# Supplementary Planning Document North of Sycamore Close, Endmoor

## Development Brief Consultation Statement

August 2017

Drop in Event comments. All responses submitted at the drop in event (28 June 2016)

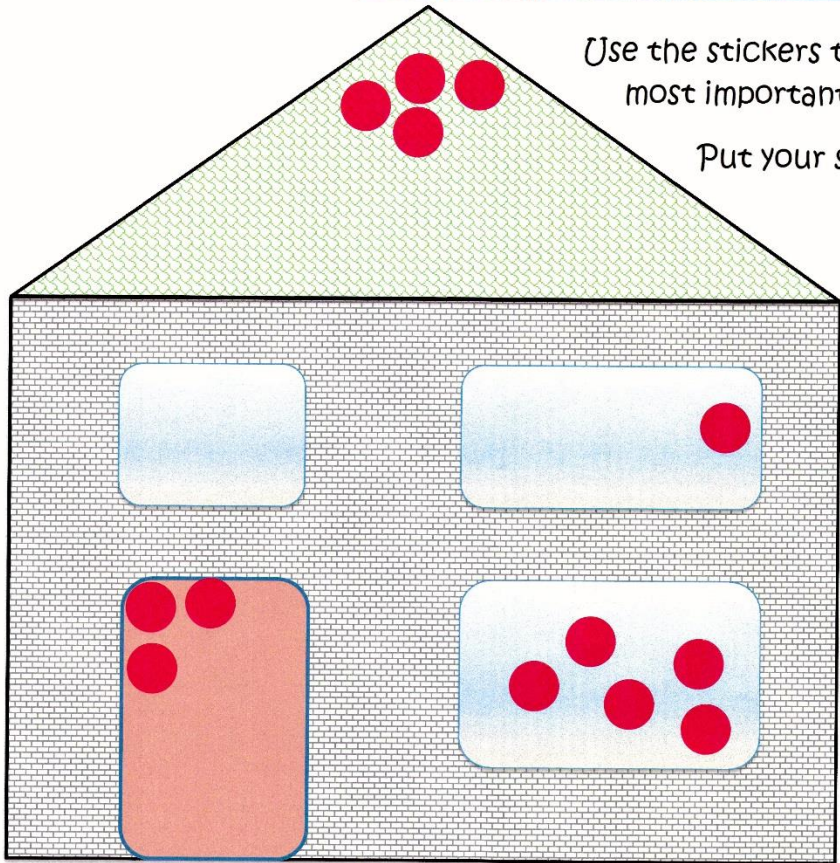
- The visual impact from Gatebeck Road, beyond The Fishery must be considered – impact on landscape quality;
- Consider how far down the contour building should be permitted. ? additional tree planting extending from existing tree line northwards;

- Tree planting along boundary with A65 development kept back from the boundary;
- ‘Self-build’ plots made available for true local development;
- Reduced housing density to match village;

- Phased development to allow a more gradual social change to the village;
- Links to footpath & playing field;
- Need more frequent bus services & timed so that can use at peak times (to work etc) – while it costs £4.50 single, people won’t use it;

## Development Brief: North of Sycamore Close, Endmoor Draft Constraints and Opportunities Map

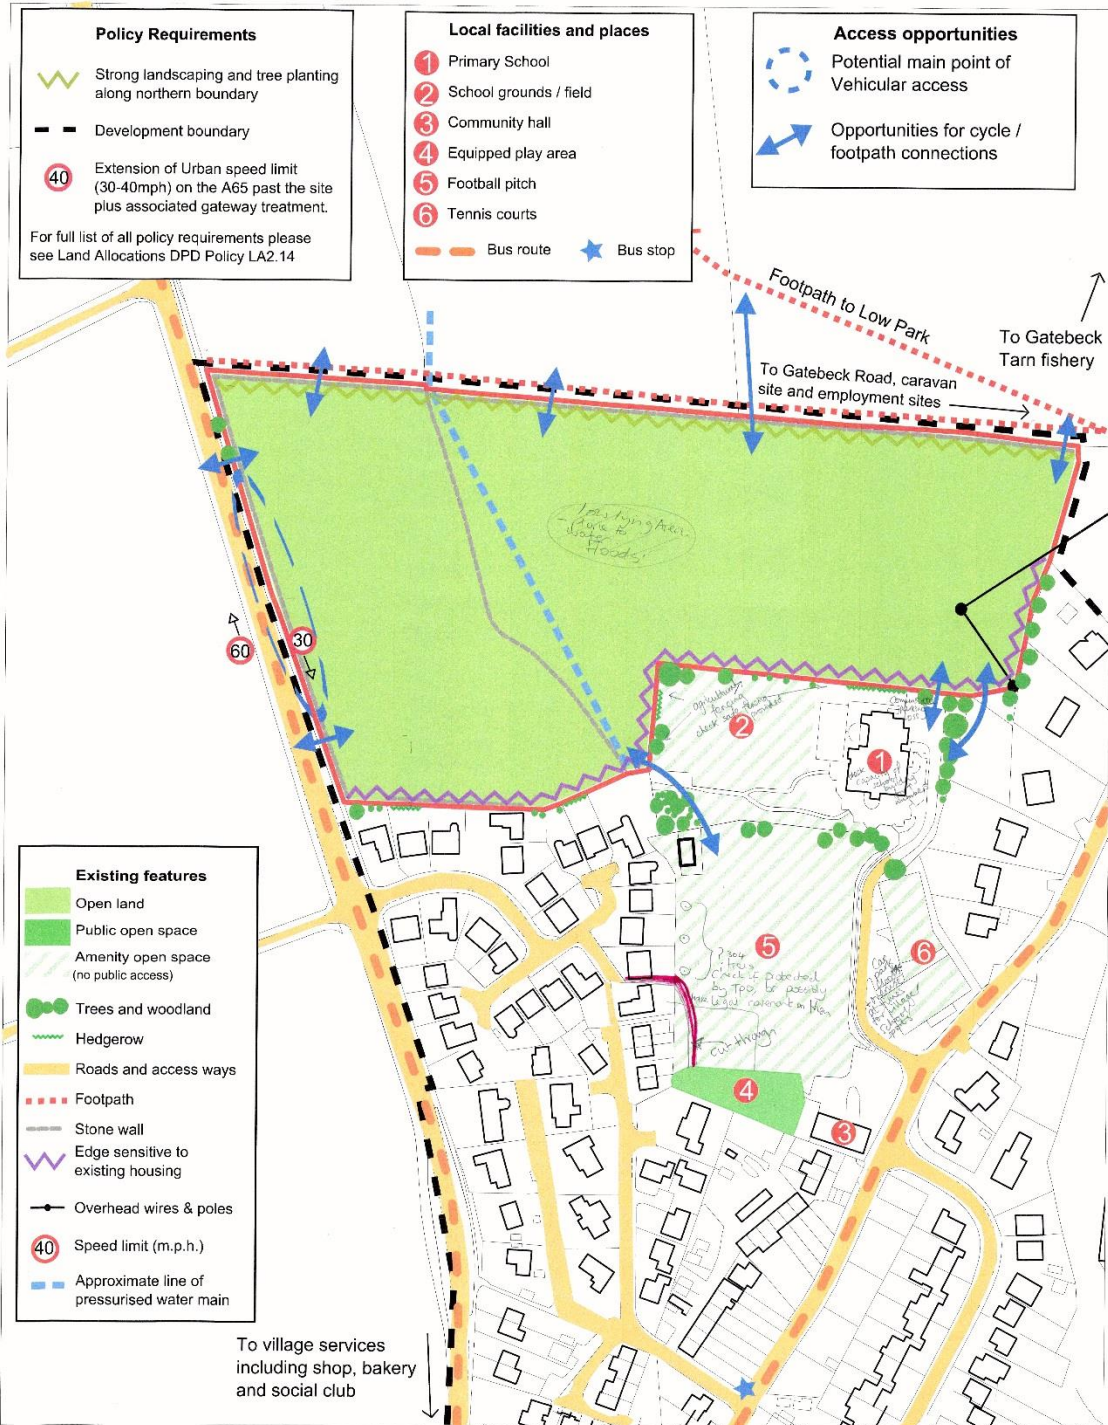
- 4.75 Reference to the 40mph speed limit indicated on the Constraints & Opportunities Map was queried. Request was made to provide a map that shows the site in a wider context including wider public rights of way network, other allocated sites and relationship to nearby settlements and opportunities for linkages (e.g. Low Park)

- Correct reference to 40mph on constraints map;
- Map to show wider footpath links between site & nearby villages (Low Park);
- Bus service needs improving to provide transport for people with jobs / access to dental / medical facilities;

Query whether 40mph reference on Constraints & Opportunities Map is correct.	<b>+ive</b> The Constraints and Opportunities map and references in the Appendix 3 (Site Information Document) has been updated in response to changes in speed limit along this section of the A65.
Map showing the site in its wider context should form part of the brief.	<b>-ive</b> The Draft Brief considers the site in its wider context and supplements the text with photographs / images. The Constraints and Opportunities and Indicative Proposals Maps need to be of a scale to clearly illustrate the site.
